UNITED STATES DEPARTMENT OF COMMERCE
Patent and Trademark Office

Office Action Summary	Application No. 09/309,844	Applicant(s) PACK, WILLIAM	
	Examiner Joseph Schell	Art Unit 3619

DETAILED ACTION

Inventor
 Harry R. Wilson
 By Harold H. Gierke
 Attorney

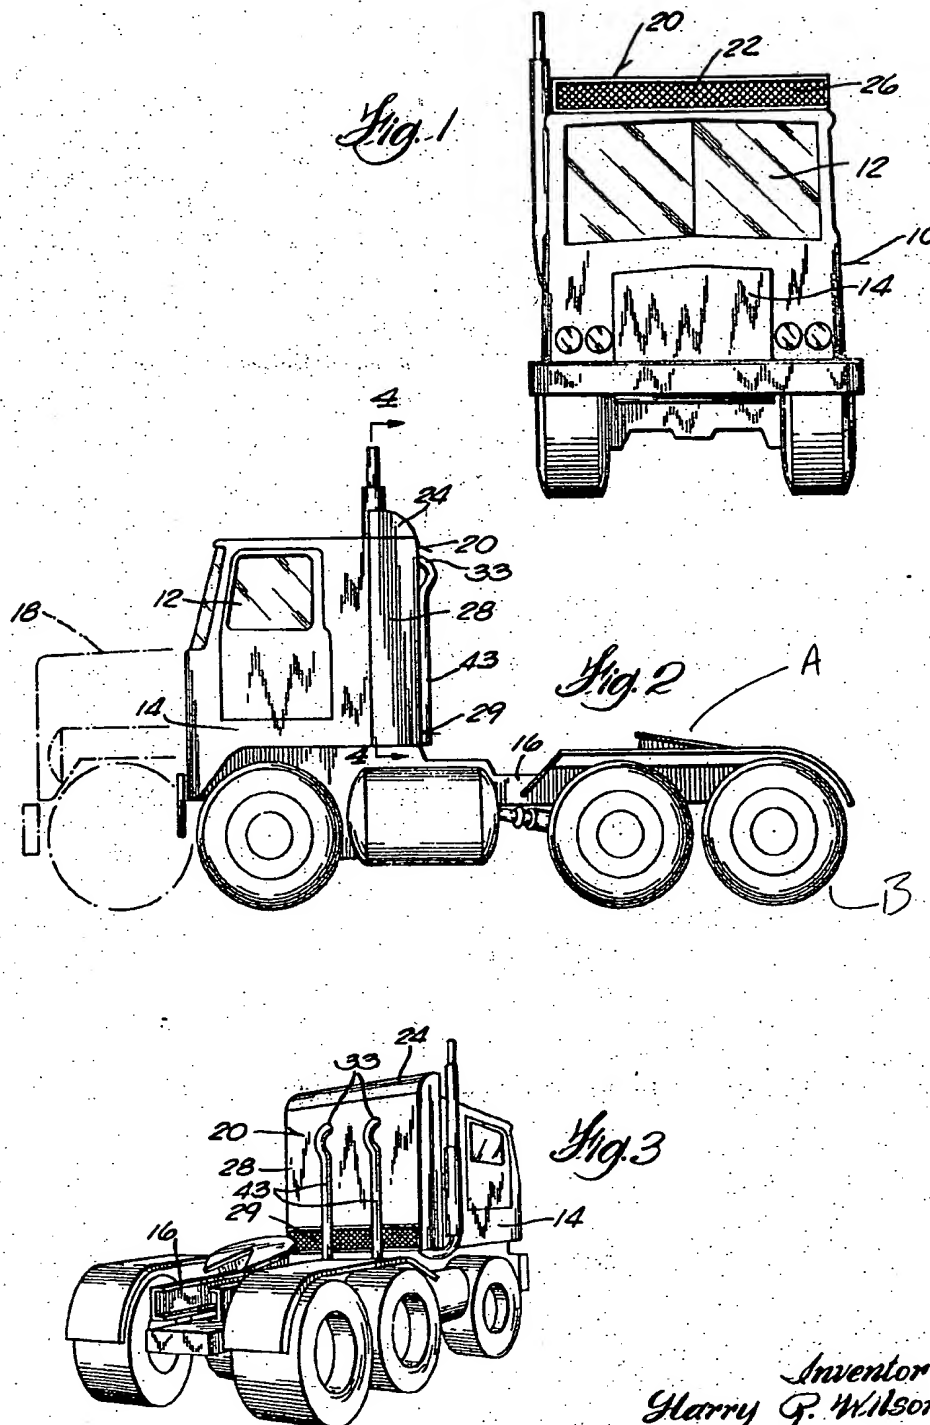
2. Claims 10, 11, 12, 14, 16, 17 and 18 rejected under 35 U.S.C. 102(b) as being anticipated by Wilson. Wilson discloses a work machine (10, see Figure 1, attached) comprising:

a cab assembly (12) mounted on the main frame such that the cab assembly is interposed between the engine assembly and the radiator assembly (see Figure 2);

wherein the engine enclosure is devoid of a radiator assembly and the radiator assembly mounted on the main frame is located outside of the engine enclosure (see Figure 2);

a work implement (A, see Figure 2, attached) coupled to the main frame and

the main frame (16) has a longitudinal axis, the radiator assembly (20) includes a cooling core (34) having an upper edge, and the cooling core is positioned relative to the longitudinal axis such that a linear extension of the upper edge defines a line L1, a line L2 is defined by a line which intersects the longitudinal axis so as to define a 90 degree angle alpha therebetween, an angle sigma is defined between the line L1 and the line L2, and

$40.0 \text{ degrees} \leq \sigma \leq 95.0 \text{ degrees}$ (see column 3, lines 51 through 67. Lines 63 and 64 disclose the cooling system could be mounted to one side of the cab, which would be perpendicular to the cab and sigma would be 90 degrees);

a work implement (A) coupled to the main frame (16), and the radiator assembly (20) is interposed between the work implement (A) and the cab assembly (12);

the radiator assembly (20) includes a radiator fan (30A) and a cooling core (34); and the cooling core is interposed between the radiator fan and the cab assembly (12);

a work implement (A, see Figure 2, attached) coupled to the main frame, and the radiator assembly (20) is interposed between the work implement (A) and the engine assembly;
